# Model Validation: Modeling Study of PCB Contamination In The Housatonic River

## A Peer Review

W.Frank Bohlen  
University of Connecticut  
Department of Marine Sciences  
Groton, Connecticut 06340

July 20, 2006

Figure 6.2-5 Comparison of Measured and Simulated Flow and Elevation at Five Stations During the October 2003 Storm Event

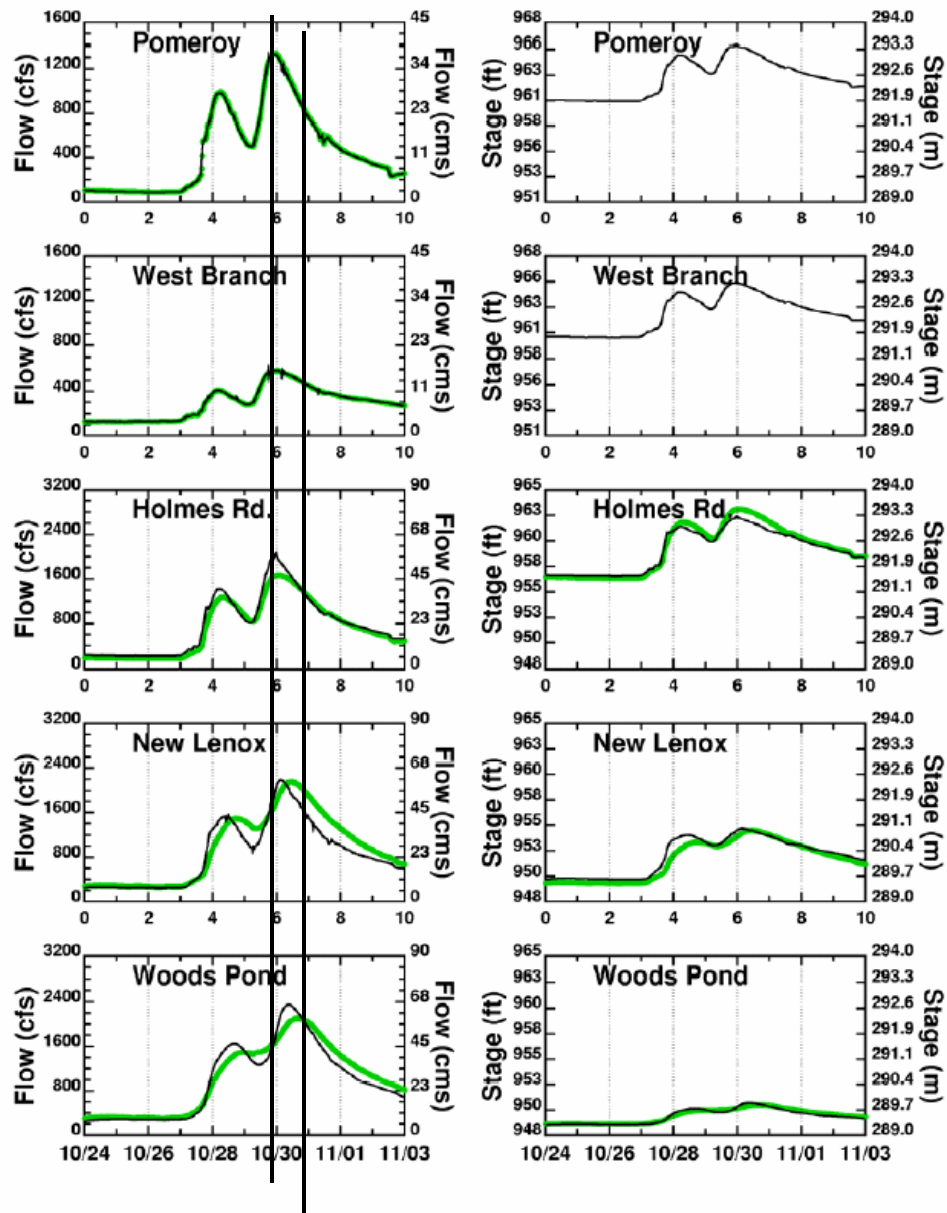
Given the importance of timing it is disappointing that the report provides so little detailed information on this factor and its effects. There is abundant reference to the model's ability to accurately reproduce event timing but these statements appear to be referring to timing in the most general sense. i.e. a precipitation event induces an increase in streamflow over a time similar to that observed. These references to "event timing" leave the question of the adequacy of the model simulation of timing with respect to flow velocities unanswered. Examination of several of the figures (see Fig. 6.2-5 (attached) e.g.) shows substantial differences between measured and modeled actual flow and stage timing at several stations along the PSA. In this figure, it would appear that the modeled speeds produced by the associated pressure gradients should be less than the measured and that the turbulence induced by adverse pressure gradients would also be reduced. Actual estimation is, of course, complicated by the morphology of the region with tributary inflows and/or backwater flows and storage complicating the simple stage discharge relationship. This factor may be the reason for example that the simulated flows at Holmes Road are higher than the measured despite a higher measured stage relative to that simulated.

Figure 6.2-8 Comparison of Measured and Simulated Velocities for Holmes Road, New Lenox Road, and Woods Pond Footbridge During the 26-Year Validation Period

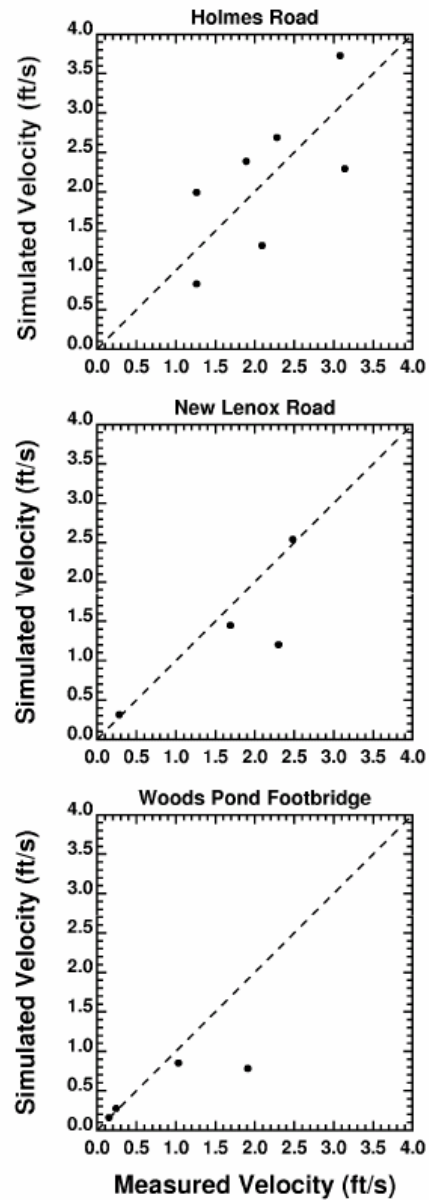
This matter of flow phase and velocity and associated effects on transport could be better evaluated if the report had provided a more complete discussion of measured vs. modeled velocities when presenting the results of EFDC hydrodynamic calculations (see pp.6-31 e.g.). Although the model uses HSPF generated flows at the upstream boundary, the resulting simulations are to some extent independent of the HSPF generated flow/stage through PSA and as a result may be less sensitive to this matter of stage timing. Speeds were measured using both electromagnetic and acoustic doppler currents meters for short periods of time at several locations within the PSA (see.Figs 4.2-26 and 6.2-8 (attached)). These comparisons, while taken to be generally acceptable, indicate to me that there is very likely a substantial difference in measured versus modeled sediment transport associated with these differences in velocity. These flow induced differences will require substantial "calibration" within the model to yield reasonable estimates of sediment/contaminant flux. Given the non-linearity of both the velocity/shear stress and the shear stress/transport relationships it will be unlikely that such calibration will result in accurate simulations across a wide range of flows. This may be the principal reason that the model, at least some locations, seems to over-predict TSS values at low flows while under-predicting them at high flows. The significance of such variations will tend to increase with the duration of the model run and may become more of a problem during the extended runs planned for the Corrective Measures Study.

Comparisons between measured and modeled velocities are complicated by the model use of a single grid cell across the main stem channel. If the single cell is to be retained measurements should be designed to yield cross-sectional averages as opposed to point measurements. The majority of available data do not appear to be suitable for this purpose.

Figure 4-21c. Depth profiles of GE high resolution cores collected within Woods Pond during 1994 - 1995.

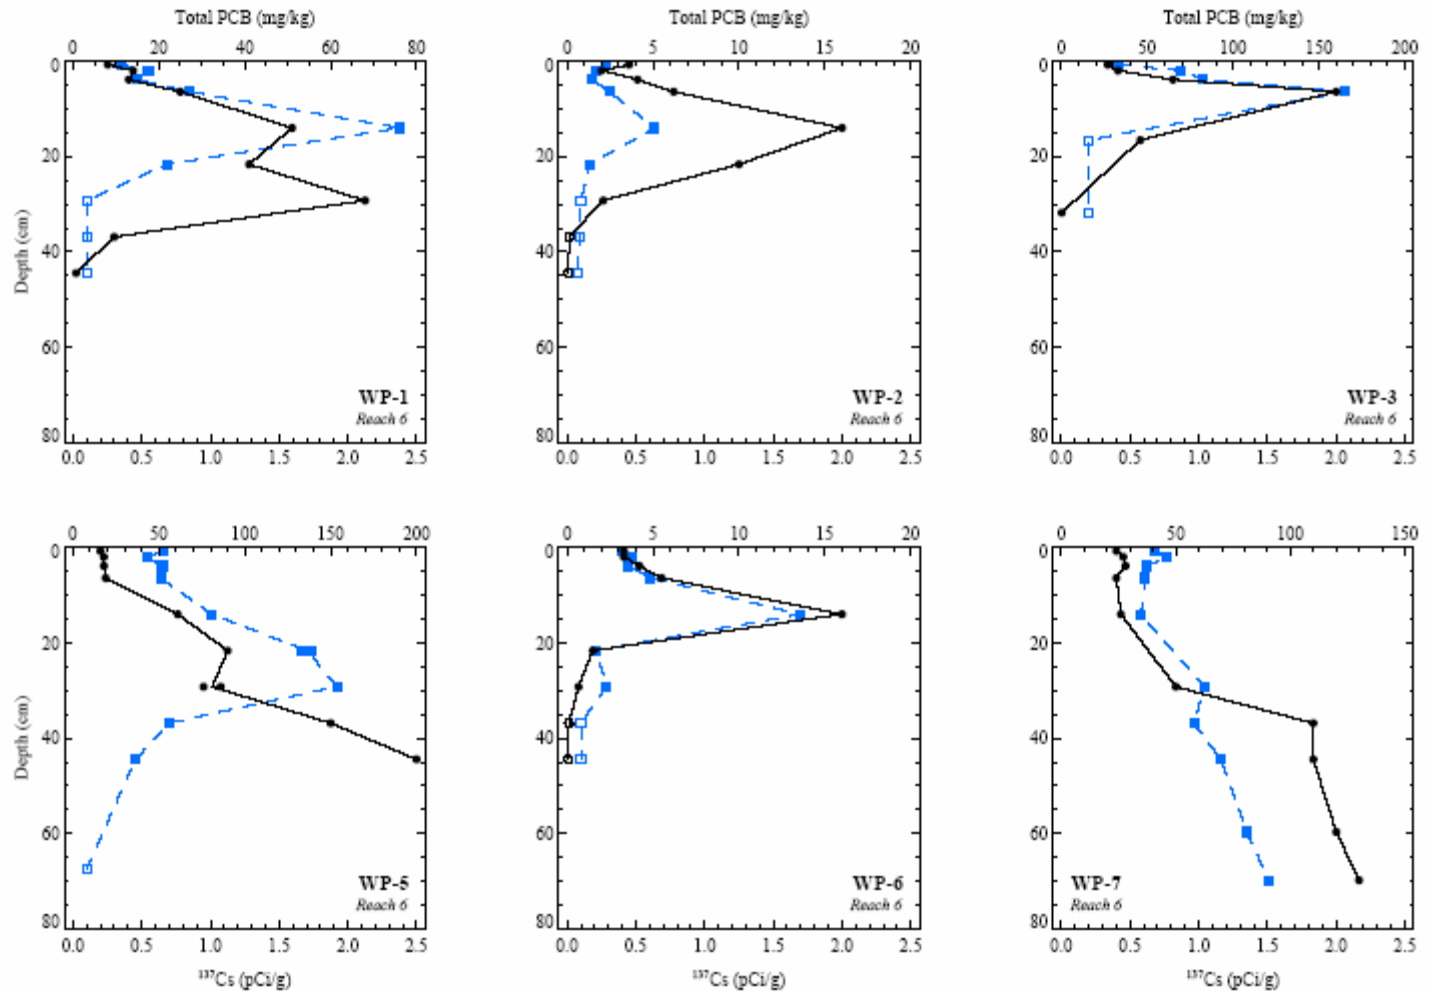
The model/data comparisons for PCBs should be extended to include consideration of distributions over the vertical. Any assumption of a well mixed layer extending over depths in excess of a few inches doesn't seem to agree with field data (see e.g. Fig. 4-21c, BBL,2003, attached). How are these differences to be reconciled ? (i.e. use of 6" well mixed layer vs. detailed core data showing little mixing beyond 1-2in). These core data and associated radio-dating also allow estimates of sedimentation rate to be compared to the mass flux data provided by the model. This comparison was not part of the validation report. It would provide an additional check on model results and is recommended.

been a matter of concern for some time. Experience in other riverine/bayou systems as well as the detailed core data (Fig. 4-21c, attached) indicate to me that the active bed used in the model is too thick. It may be that this specification in terms of physical transport characteristics has relatively little effect on overall model results (although that might bring up another set of questions). A test of model response to this characterization is recommended.
